**PROJECT NUMBER / TITLE: Z-20-01(PDP-20-01):** Rezoning from County RUR, PRB2, and PEC3 Districts to City of Gardner Districts RP-1 and RP-2 and associated preliminary development plan for Prairie Trace

**Type of Request:** Rezoning and Preliminary Development Plan

# PRELIMINARY PLAT & PLAN FOR PRAIRIE TRACE IN THE CITY OF GARDNER JOHNSON COUNTY, KANSAS

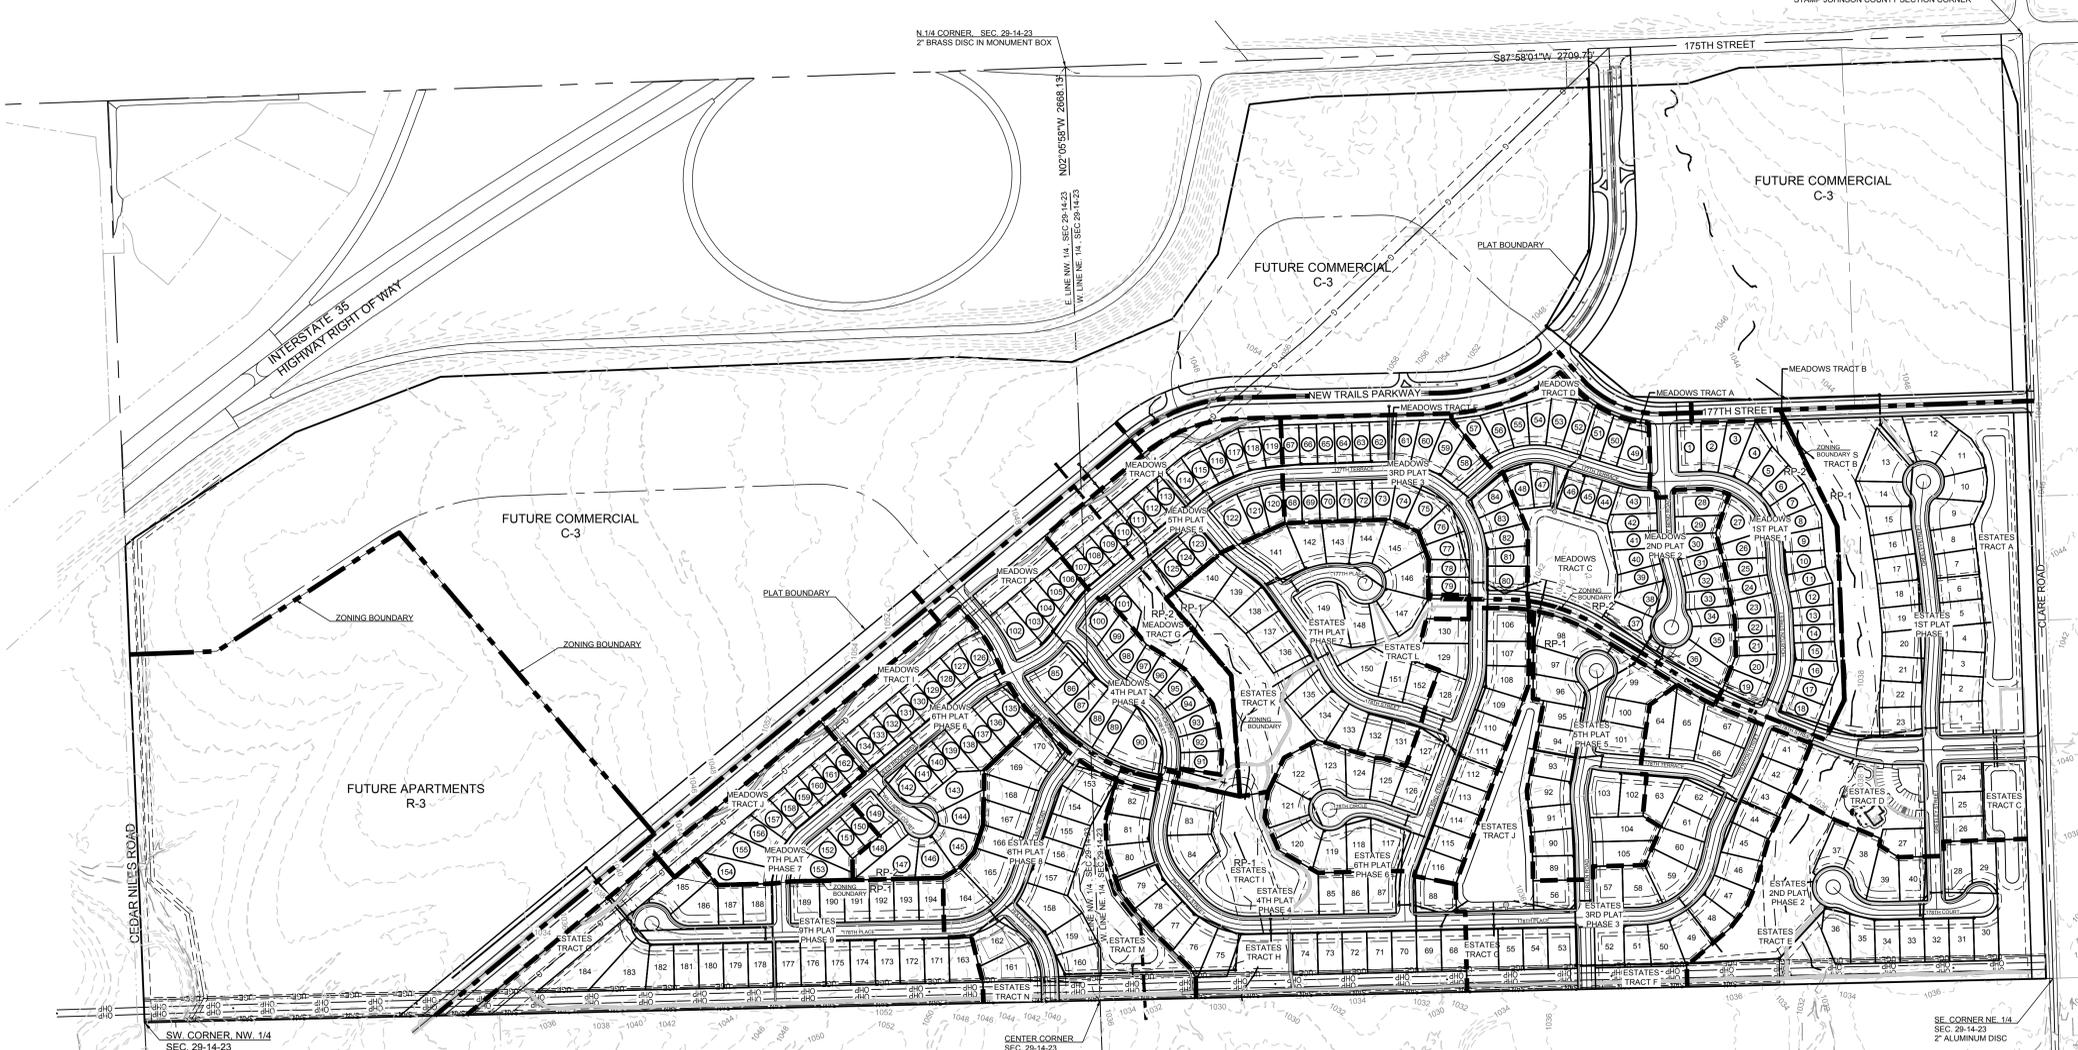
**Staff Comment:** *The applicant is requesting a 5' reduction (25' min to 20' min) in the rear setback on the 'Estates' lots that are adjacent to greenspace. By limiting this potential building increase to lots adjacent to open space (on rear or side), it offsets the impact of potential increase in building footprint. Staff has identified lots that are not adjacent to open space including lots that have less than 50% of the rear or side lot line length or lots adjacent to open space that does not have enough depth to make the intended impact. As such, the following lots in the 'Estates' area should meet the 25' minimum rear yard setback: Lots 28, 39, 40, 57-67, 82, 86, 87, 96-108, 117-119, 123-128, 131-133, 141-146, 152, 153, 162, 164-170, 186-194. This is 61 of the proposed 194 'Estates' lots or 31%. Staff support this deviation on all of the 'Estate' lots with the exception of the lots outline above.*

**Staff Comment:** *The applicant is asking for a 10% increase in lot coverage on the 'Estate' lots. As stated above, lots adjacent to shared open space can utilize that open space as mitigation to the reduction in lot open space. As stated in the above deviation staff comments,*

The summary table below provides calculations based on the diagrams for proposed driveway configuration on the front page of the plans. The requested deviation will need to be revised to reflect what is shown in the diagram in order to allow for the driveway to widen to 3 car garage width.

**Staff Comment:** *The Neighborhood Frontage Type permits access width limits of 15% of the lot width up to 20' maximum, which for a standard 50' wide lot in the "Meadows", the driveway would be permitted to be 7.5' wide. The Neighborhood Frontage does not allow for the width of the drive to change until the building setback line, so the max width would be 7.5' all the way to the front building line. This is not what the applicant has diagramed on page 1 of the plans.*

7. Trail and pedestrian amenities shall be installed with the development of the phase in which it is platted.
8. Update the Deviation outline on the plans to note that ‘Estate’ Lots 28, 39, 40, 57-67, 82, 86, 87, 96-108, 117-119, 123-128, 131-133, 141-146, 152, 153, 162, 164-170, 186-194 shall meet the 25’ rear yard setback minimum.

9. Update the Deviation outline on the plans to note that ‘Estate’ Lots 28, 39, 40, 57-67, 82, 86, 87, 96-108, 117-119, 123-128, 131-133, 141-146, 152, 153, 162, 164-170, 186-194 shall meet the 30% Building Coverage maximum.

10. Update the Deviation outline on the plans to note that ‘Meadows’ Lots 19-36, 42, 43, 58, 59, 68-79, 84-90, 99, 100, 120-125, 135-154 shall meet the 25’ minimum rear yard setback.

11. Update the Deviation outline on the plans to note that ‘Meadows’ Lots 19-36, 42, 43, 58, 59, 68-79, 84-90, 99, 100, 120-125, 135-154 shall meet the 40% Building Coverage maximum.

17. Revise the deviation requests on the first three pages of the plan to reflect what has been approved.
18. Provide a 10' easement along the south side of Meadows Lot 79, east side of Estates Tract H, and along the west side of Estates Tract G.

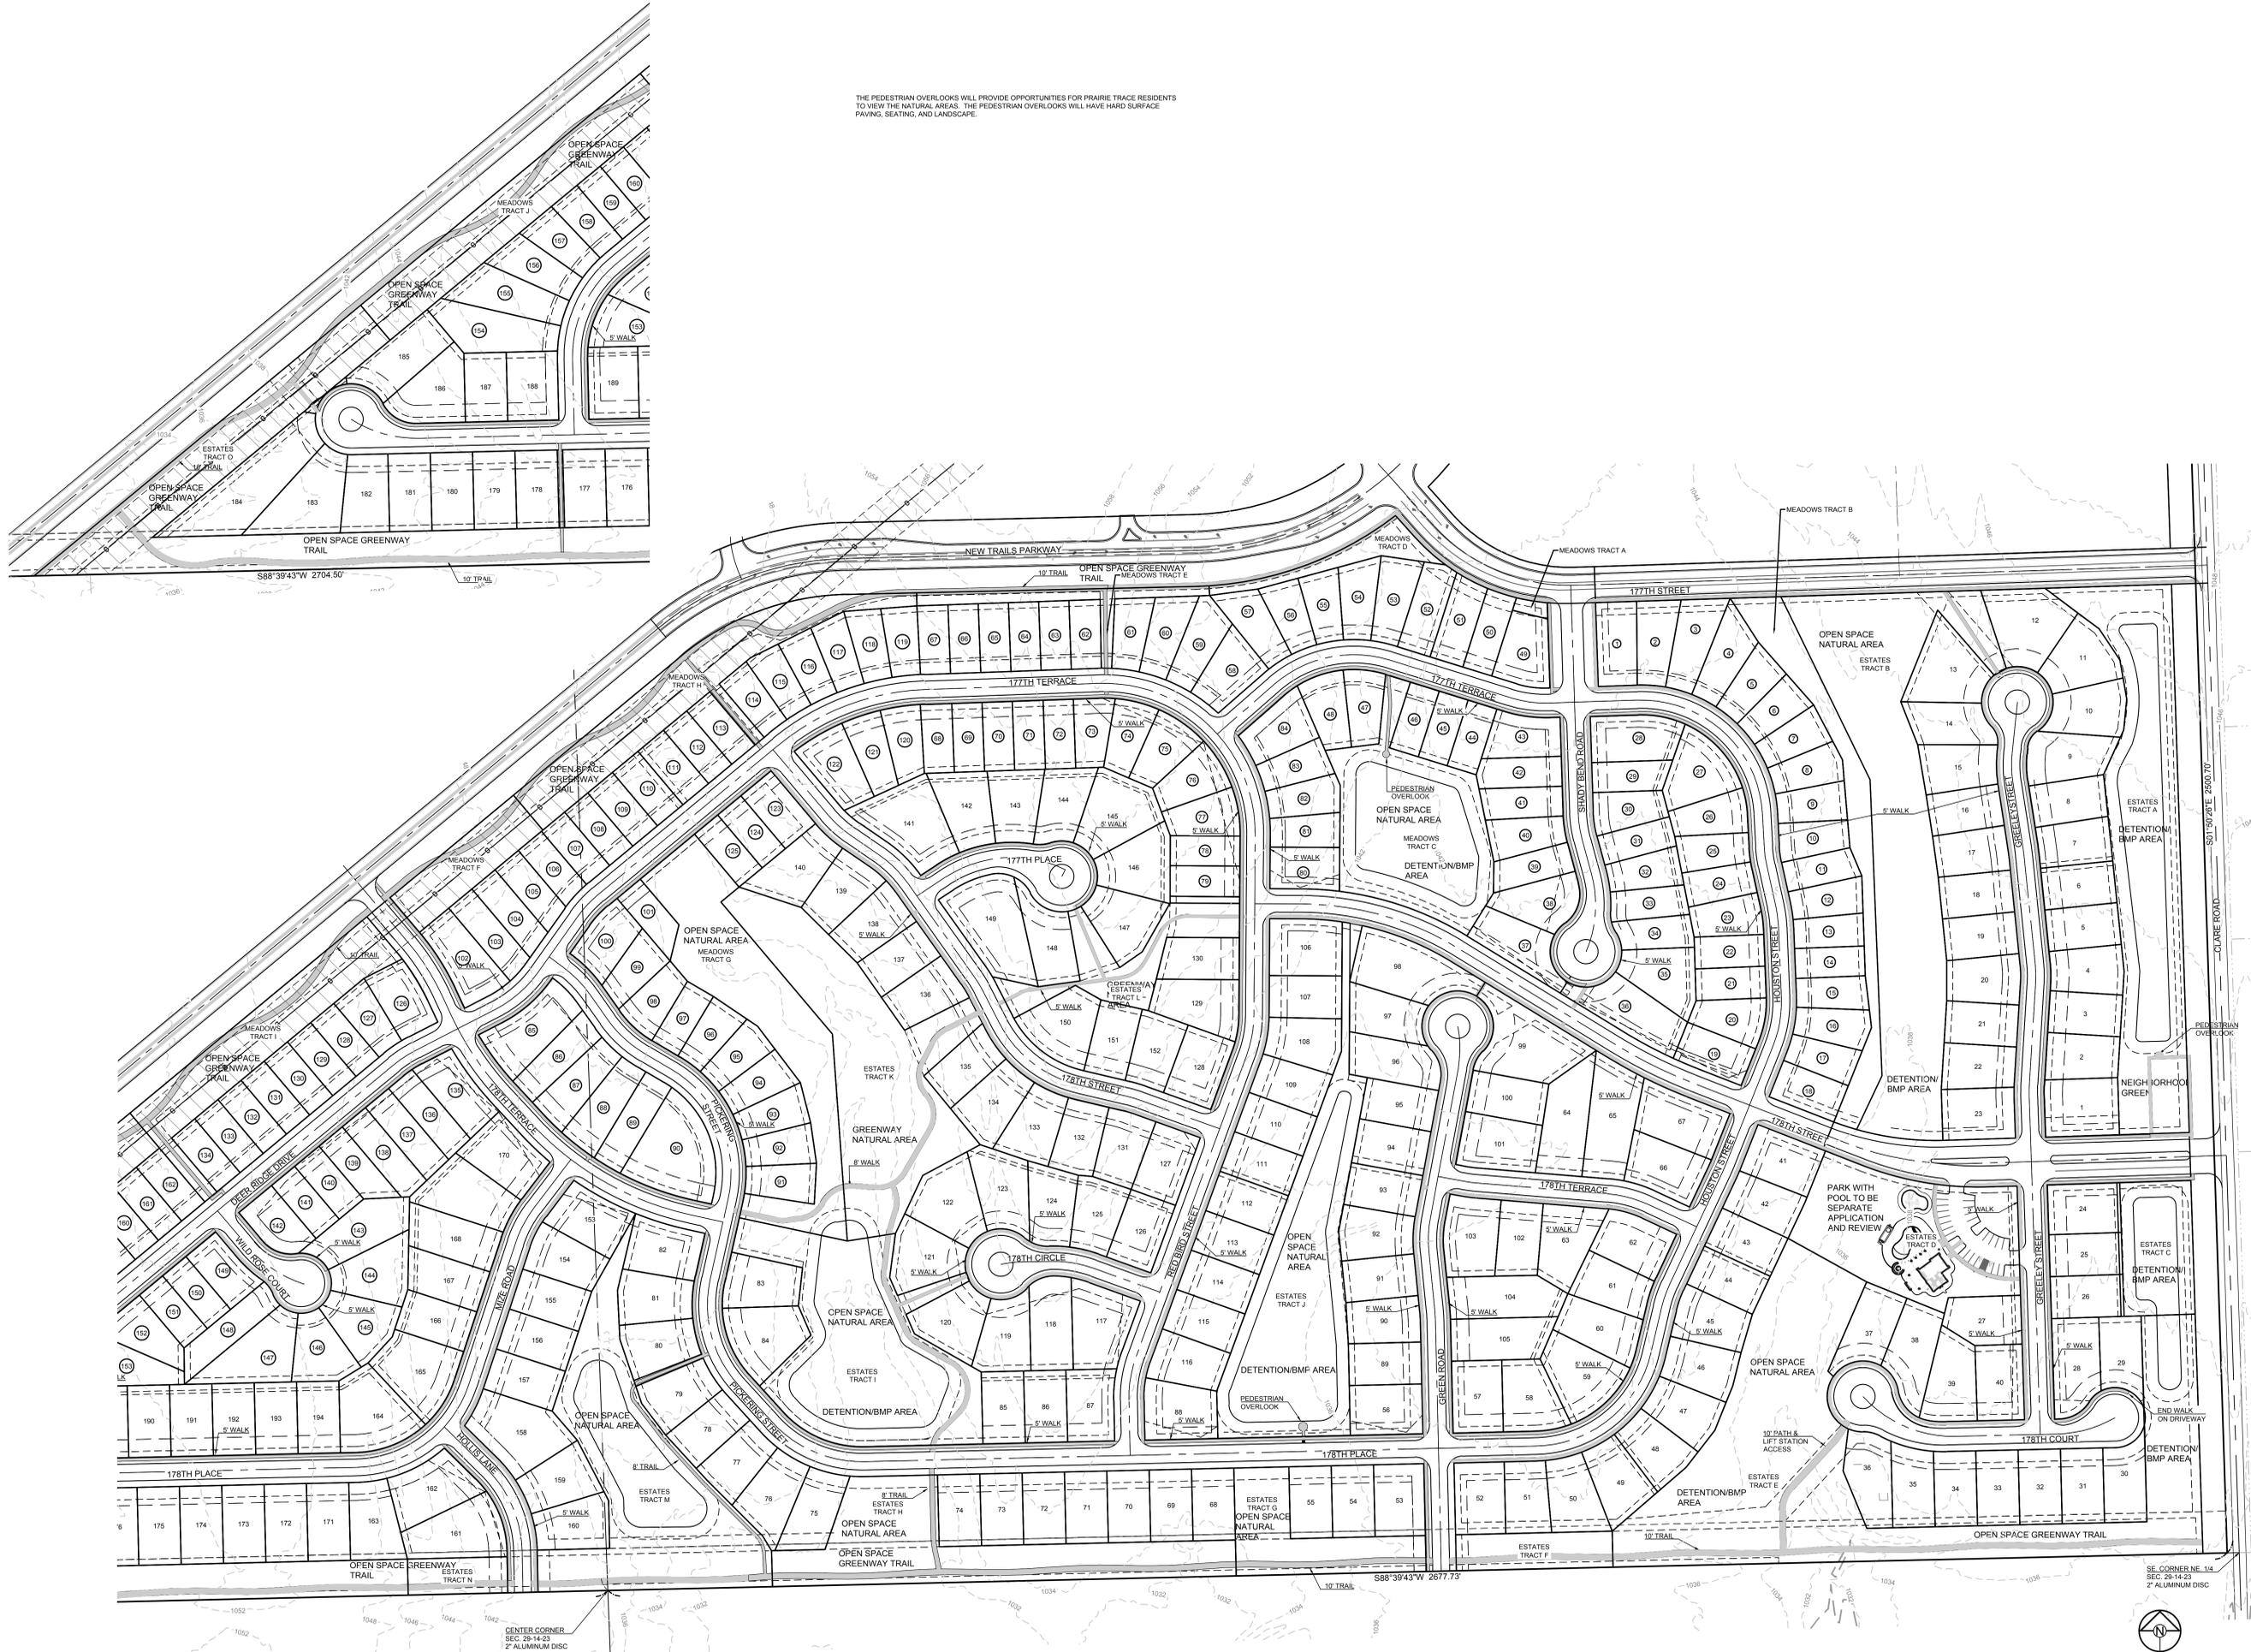
**Staff Comment:** *The Land Development Code supports pedestrian connectivity and requires sidewalks on both sides of a street. The previous Code also supported sidewalks on both sides of the street. Additionally Public Works standards requires sidewalk on both sides of the street. The applicant has proposed for each lot to either have a sidewalk along the street in front of the lot or be adjacent to either a public trail or private trail/walkway. Some streets do meet the standard of having sidewalks on both sides of the street and the others provide pass through (mid-block) pedestrian connectivity. Staff feels that this proposal meets the intent of pedestrian connectivity and supports this deviation.*

The Neighborhood Local street design requires a 5' sidewalk along both sides of the street. The applicant has proposed to provide pedestrian connections to all lots either by sidewalks on one side of the street or an adjacent trail. This is discussed in the deviation requests above.

4. Change notes indicating a 10’ asphalt trail along New Trails Parkway to be a 10’ concrete trail.
5. Provide a written agreement that Southern Star has reviewed the plans and agrees to the proposed street crossings and 10’ concrete trail and associated easements to be located within their 66’ gas pipeline easement.

PEDESTRIAN PLAN

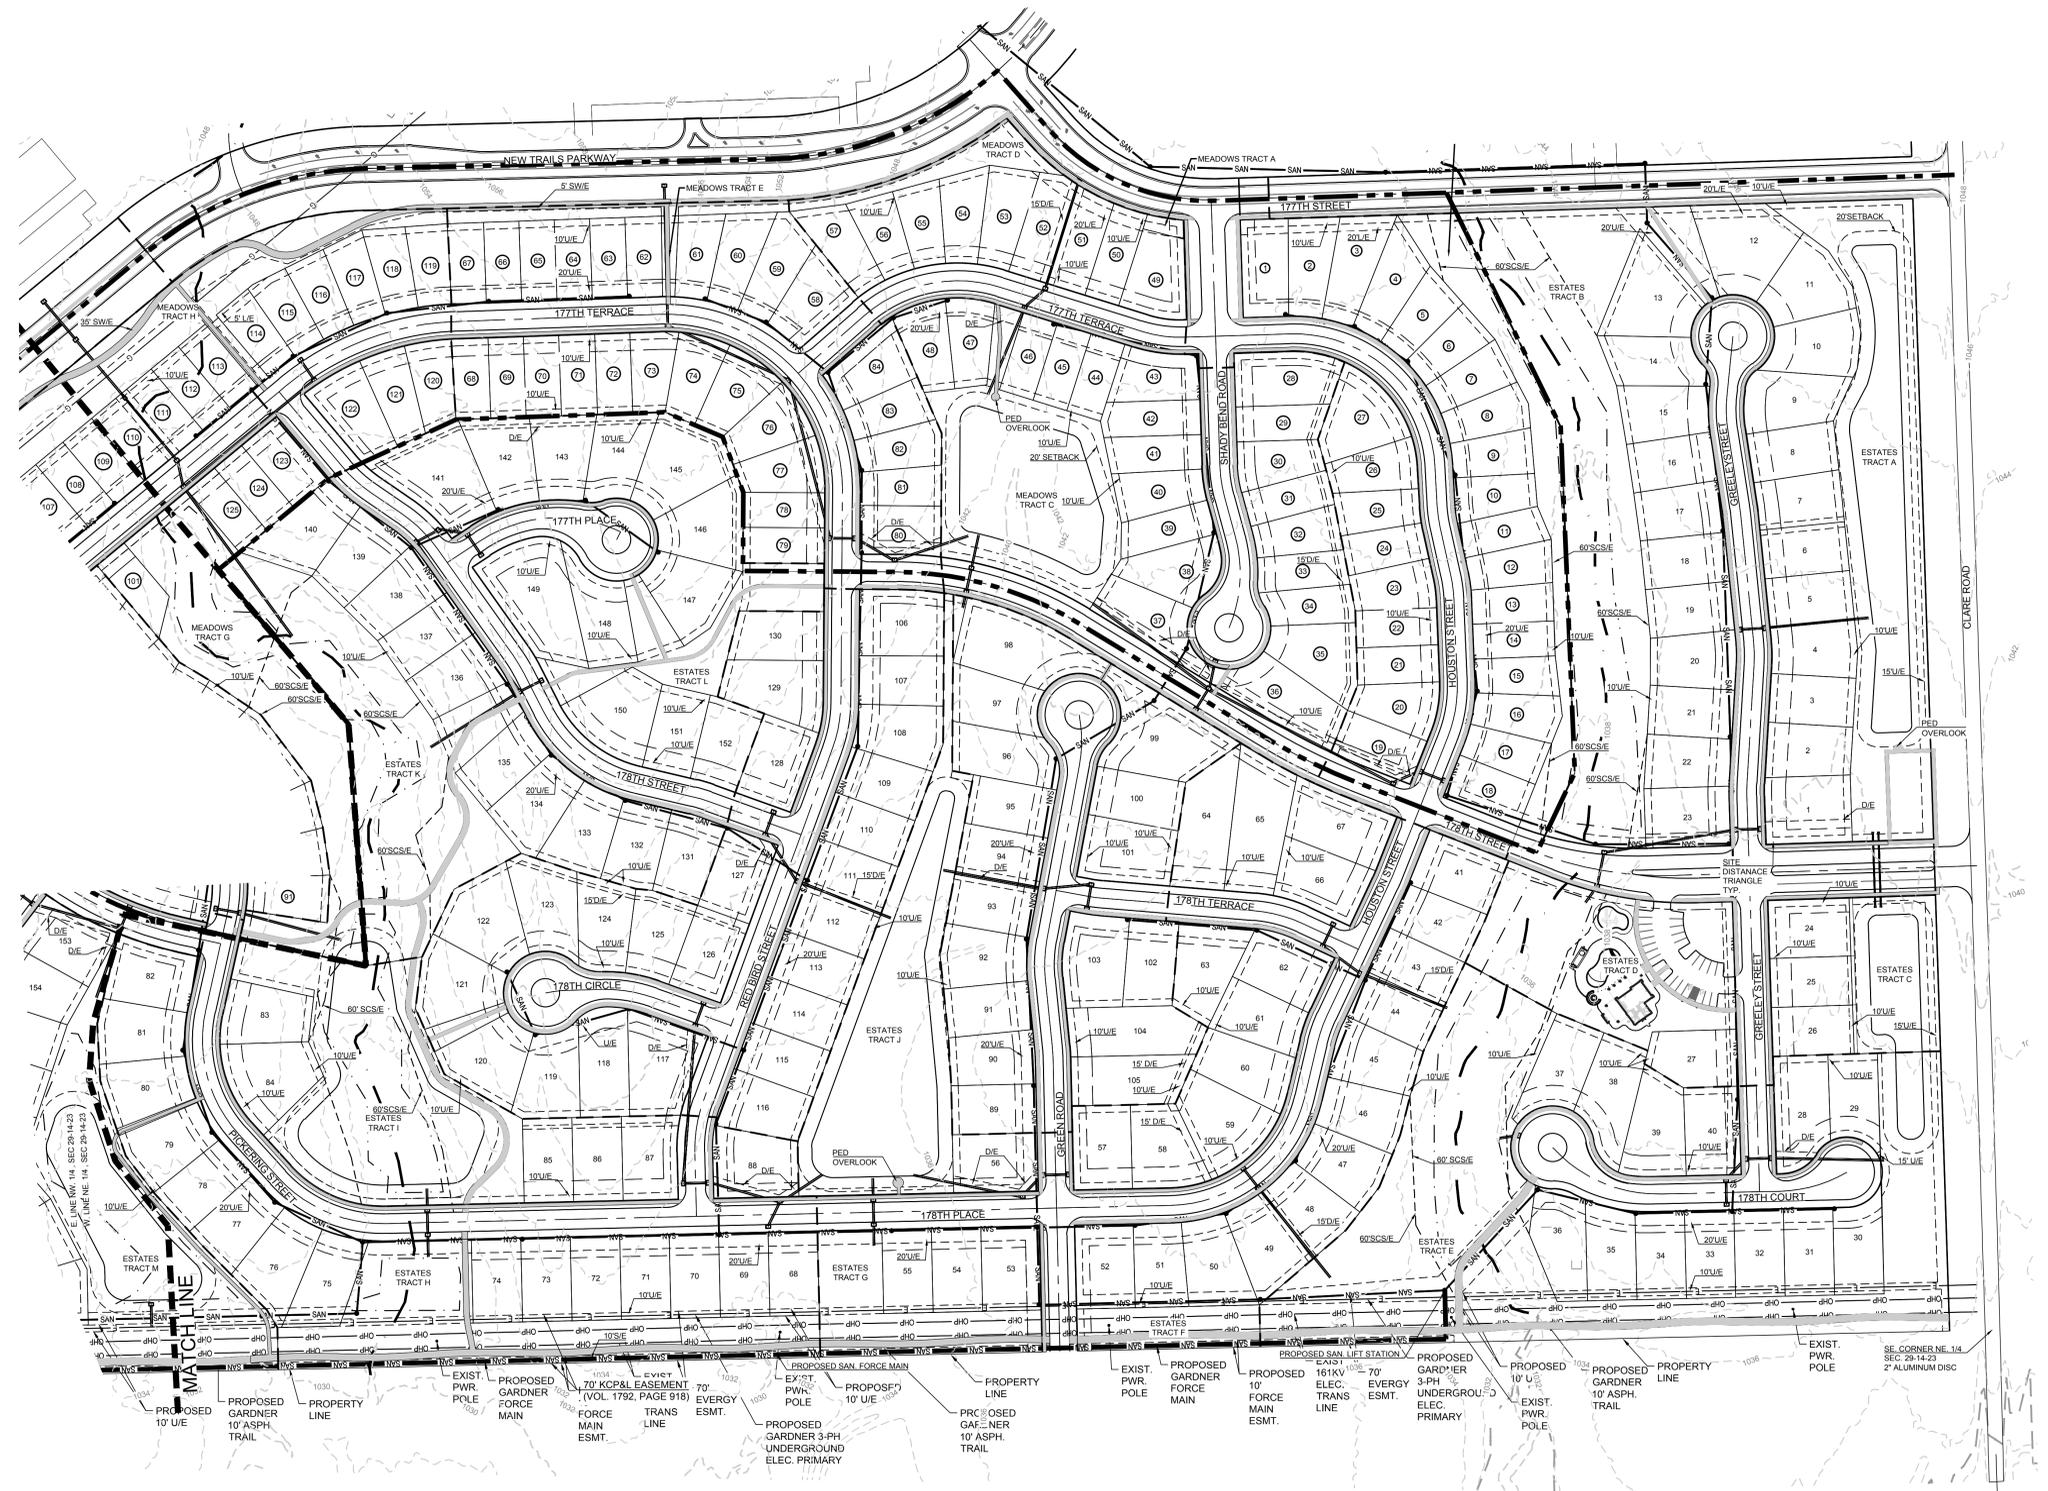
**Staff Comment:** *The plan reflects generally accepted planning and urban design principles by preserving and protecting wetland and stream areas and utilizing the utility easements that are undevelopable to provide pedestrian trails and connectivity throughout the development.*
